Bulletin No:2005 CB 01
Release Date: October 21, 2005
Effective Date: October 21, 2005
Supersedes:
Completion Date: Immediately
Page: 1 of 2

SERVICE BULLETIN

Ride Manufacturer: Zamperla SPA	Affected Production Dates: From 1997 to 2003
Ride Name: Crazy Bus, Sub & Fire Chief	Affected Serial Nos.: From 1997 to 2003
Model Number: Same	
Abstract Of Issue: Cracks have been detected on the boom arms.	
Reason For Release: Same.	
Action To Be Taken: Perform a visual inspection of the area indicated on the attached drawing. Contact Zamperla if a crack is detected.	
Detail Of Issue: Drawing of boom arm with the area indicated (page 2 of 2).	
Future Action To Be Taken: None.

DATE	17/12/2004	BY	
DESCRIPTION	CRAZY BUS/SUBMARINE		
OPERATION	MONTAZIONE		
ASSEMBLY	ASSEMBLY		
REPAIR FOR	9262154006A	REPAIR FOR	9262154006A

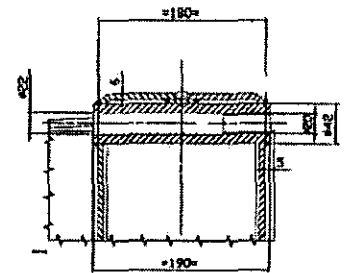
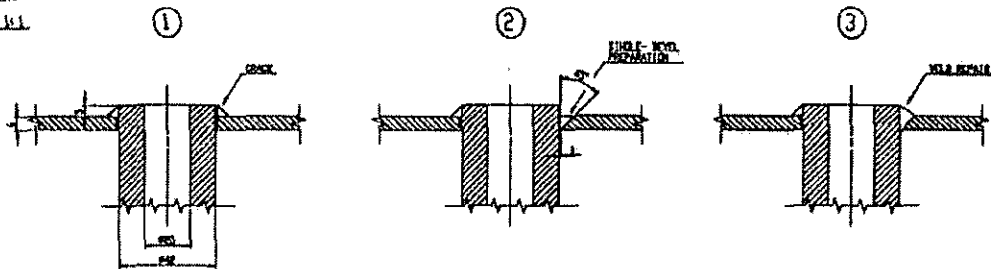
Inspect Here

Inspect Here
